PLANT NAME: Duane Arnold Plant

RECEIVED 1748 ON FEB 2-13-76
INSTRUCTIONS FOR AMENDMENT OF THE RELOAD NO. 1
LICENSING SUBMITTAL FOR DUANE ARNOLD ENERGY CENTER

PROPOSED CHANGE RTS-53 TO DAEC TECHNICAL SPECIFICATIONS

PROPOSED CHANGE RTS-42B TO DAEC TECHNICAL SPECIFICATIONS

Figure 6-9a. Delta MCPR versus Rod Position - 7x7

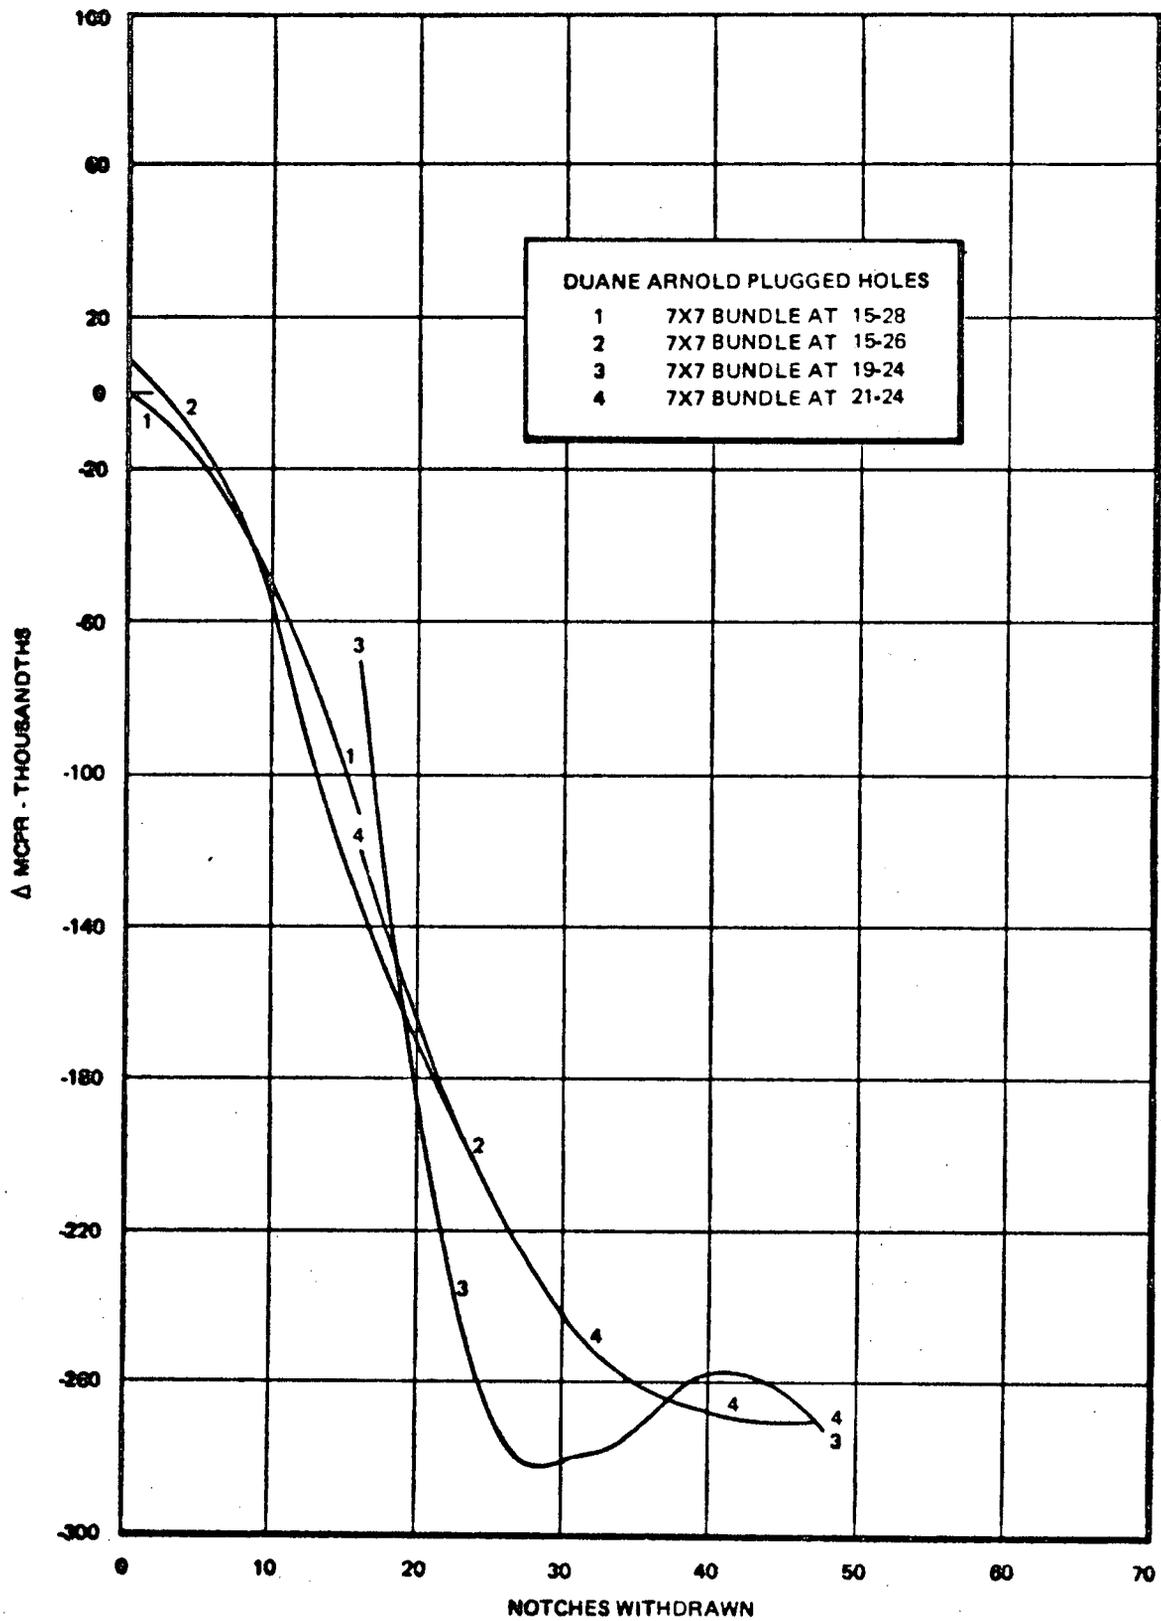
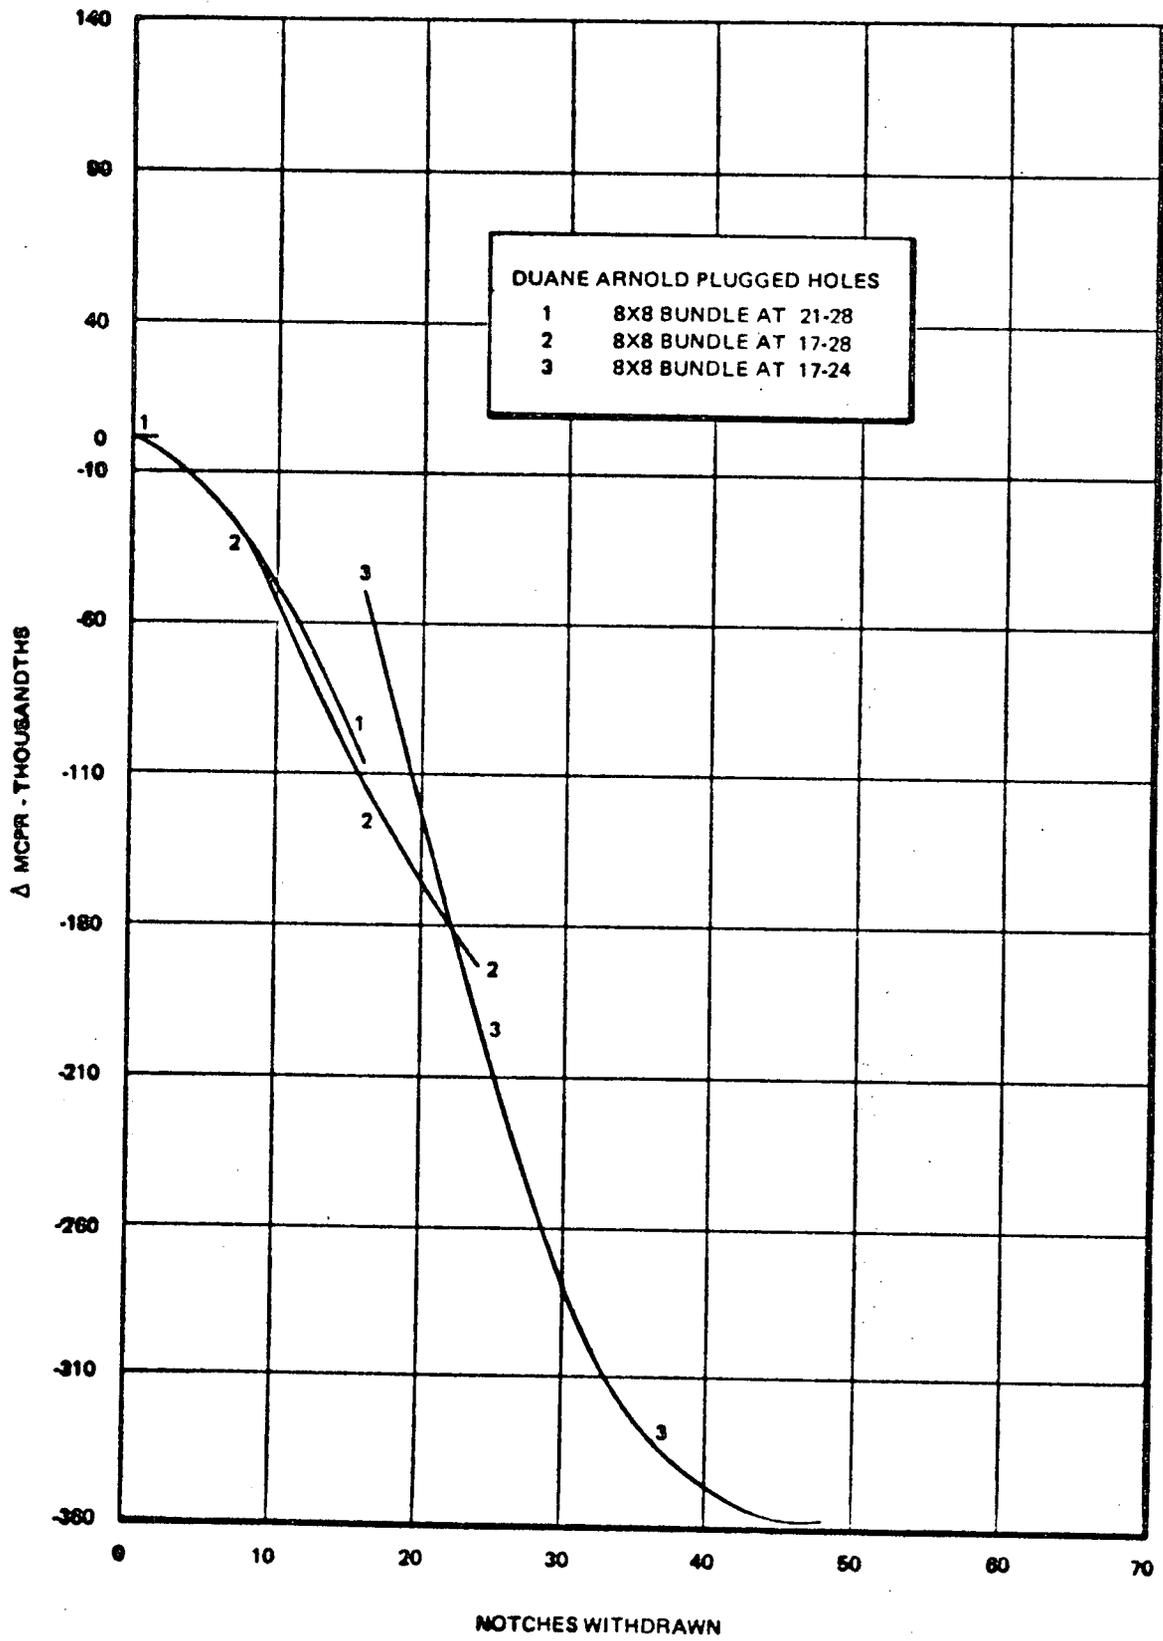
Assumptions and descriptions of rod withdrawal error are given in Reference 1. Figures 6-9 through 6-11 show the results of the worst case condition for Duane Arnold Energy Center Reload-1. The rod block monitor (RBM) set point of 107% is selected to allow for failed instruments for the worst allowable situation. This case demonstrates that even if the operator ignores all alarms during the course of this transient, the RBM will stop rod withdrawal when the critical power ratio (CPR) is 1.21, still greater than the 1.07 MCPR safety limit.

Figure A-1. Core Plate Normal Operating ΔP versus Plug Design Life to Maintain a Preload Margin of 2

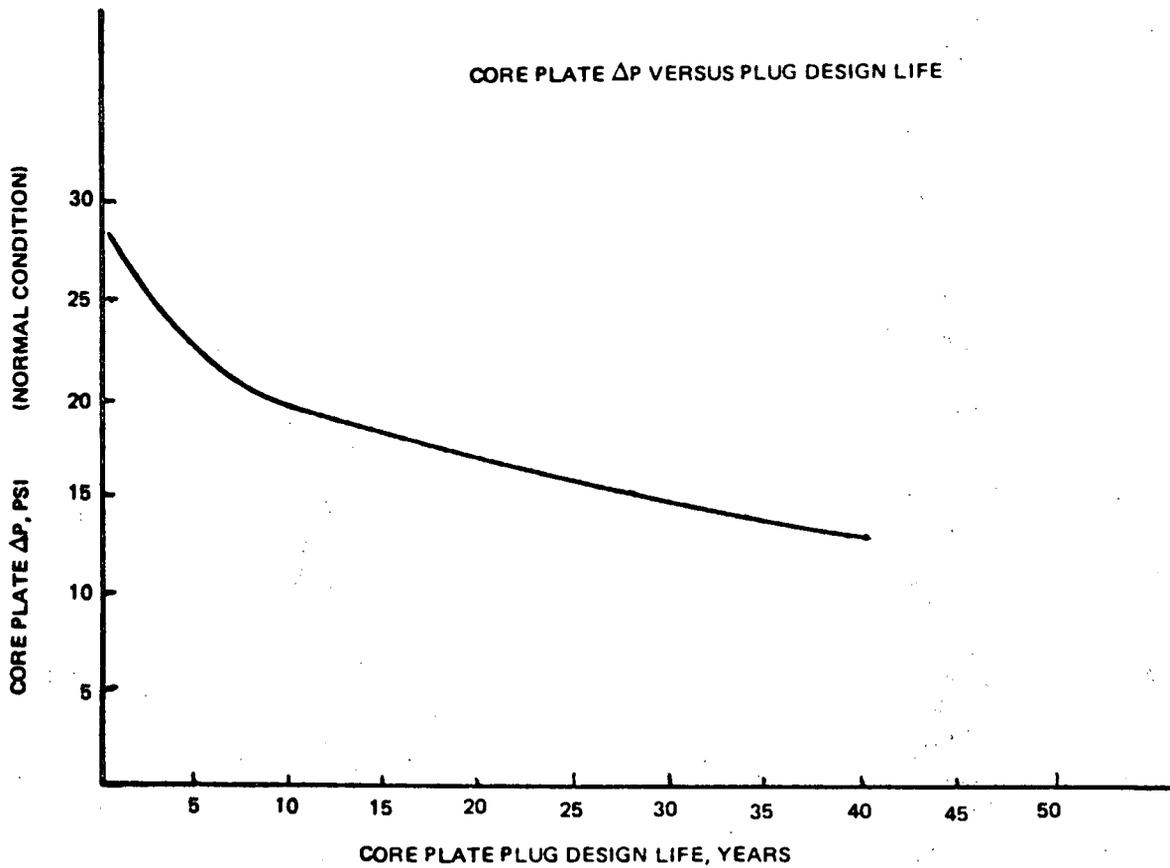
Appendix A to this report discusses the adequacy of the bypass flow hole plugs with a 27.5 psi pressure differential across the plugs. Actual measurements of this differential during plugged operation at 100% flow at DAEC were 24.0 psid. Figure A-1 indicates that the design life for this condition is four years.

The plug design life is established on the basis of the spring preload margin of 2 times the normal operating static pressure differential force across the plug. The limiting normal operating static pressure differential force against the plug is always less than the available preload and the plug body will remain seated in the bypass flow hole during limiting normal operating conditions for 35 years of reactor service. However, the preload margin is decreased from 2.1 to 2.0 at the end of 1 year for plugs exposed to 27.5 psi pressure differential. Figure A-1 shows the plug design life as a function of the normal operating core support plate differential pressure to maintain a preload margin of 2. Duane Arnold has a normal operating pressure differential of less than 27.5 psi and the extended plug life is determined from Figure A-1.
